TO: Design Review Commission
FROM: Sean K. Gallegos, Assistant Planner
SUBJECT: 15-SC-42 – 231 Yerba Buena Avenue

Approve design review application 15-SC-42 subject to the listed findings and conditions

231 Yerba Buena Ave. Response to Comments

Panoramic photo taken standing at balcony level 11'-0" above grade at approximate location of the balcony with current landscape.

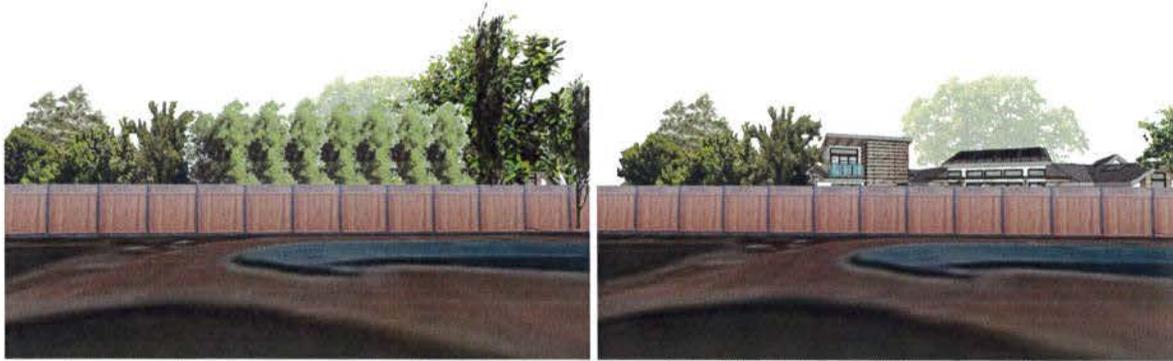
Model view towards 245 Live Oak Lane from balcony with and without proposed landscape and neighbor house showing in the background.

With the lowered roof line and added landscaping, you can see that the new development will be hidden from view of the neighboring properties and views from the balcony into neighbor's yards will be blocked. With care and maintenance, privacy should not be an issue.
